**SUBJECT:** Addendum No. 2

**REFERENCE:** Invitation To Bid (ITB) for the IAH Term C Helix Ramp Bearing & Misc. Repairs at George Bush Intercontinental Airport; Solicitation No. H06-HELIXC-2024-006; Project No. 235A

SHEET No. SJ001 SCALE: As indicated

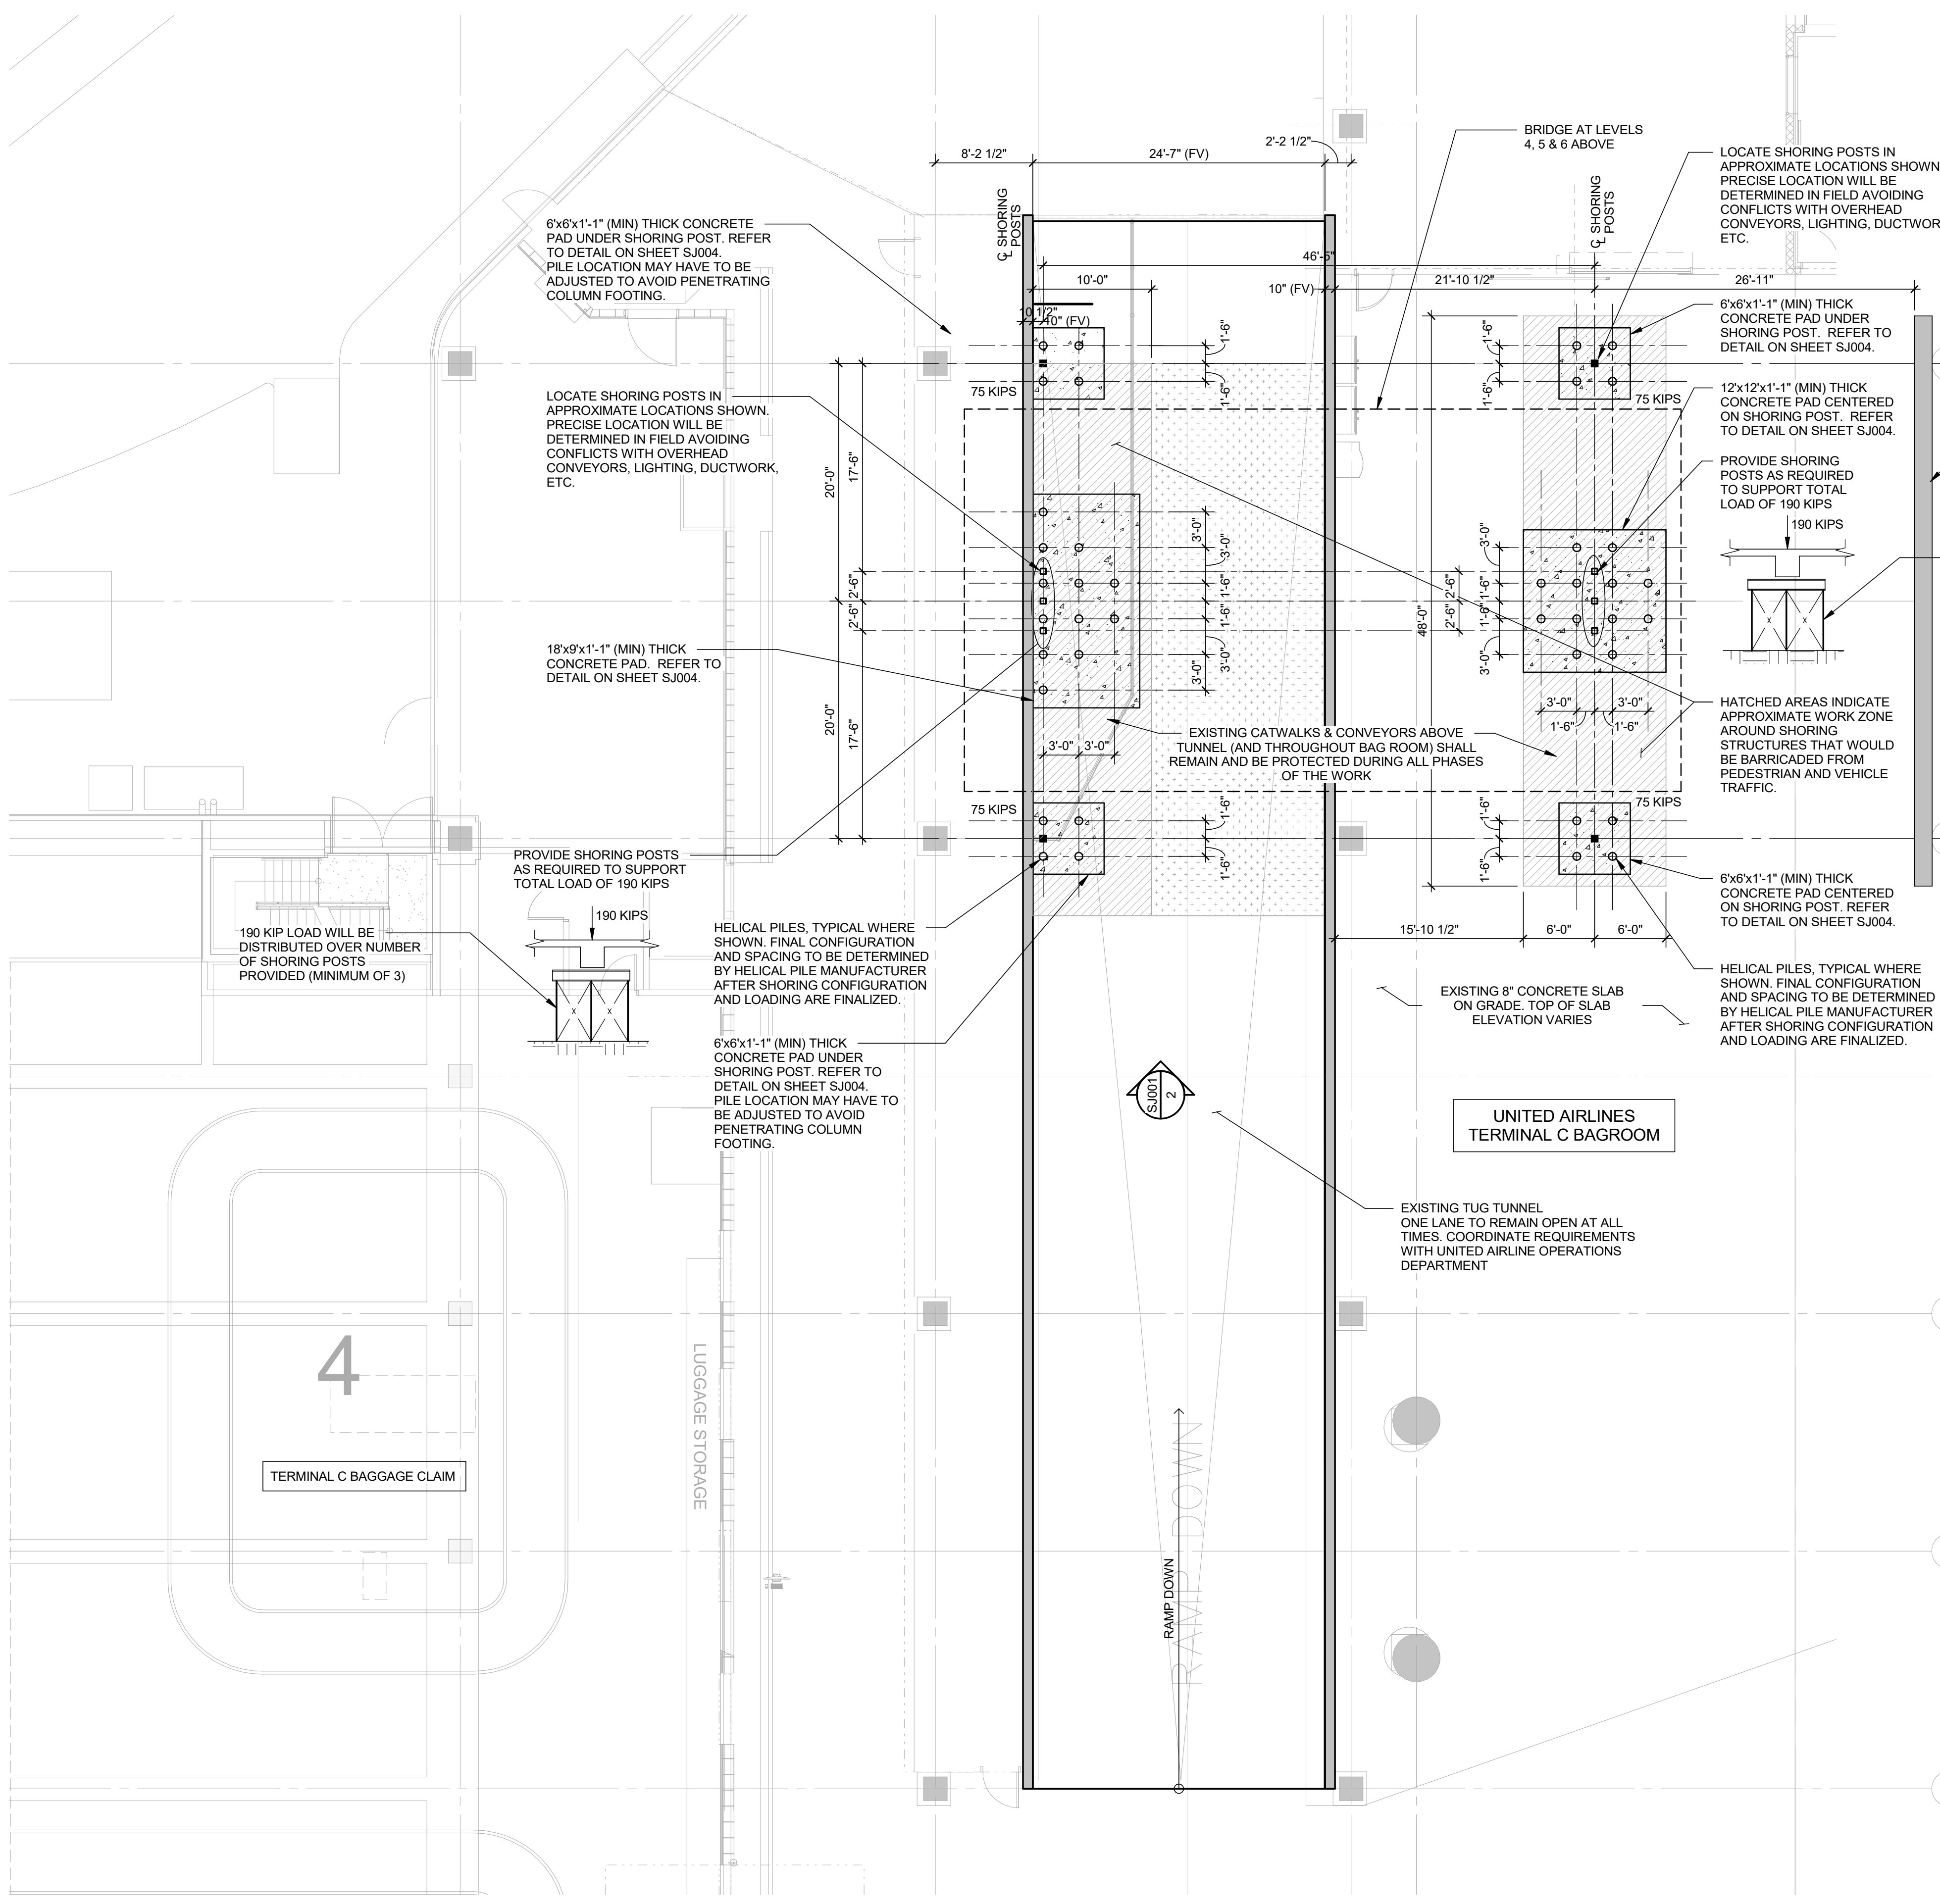
7. **Question:** Please clarify what work areas the contractor will have for the following: concrete surfacing, plumbing (drains), staircase work, staircase enclosure and awnings, concrete repair, and bridge jacking.

**Response:** For helix bridge repairs: Approximate work area is indicated for shoring placement in baggage room (see sheets SJ001 and SJ002). Refer to the traffic control plans for the upper-level work. Also refer to Part VIII General Sequence of Work on Sheet SF002 for additional notes critical to understanding constraints of the project. Refer to Sheets A1-201A, A1-201B, A1-301B, A1-401B, and A1-501B for laydown areas and areas of work. However, awarded Contractor will review and coordinate the final laydown areas and areas of work with HAS Parking Management, United Airlines, and HAS Operations Departments.
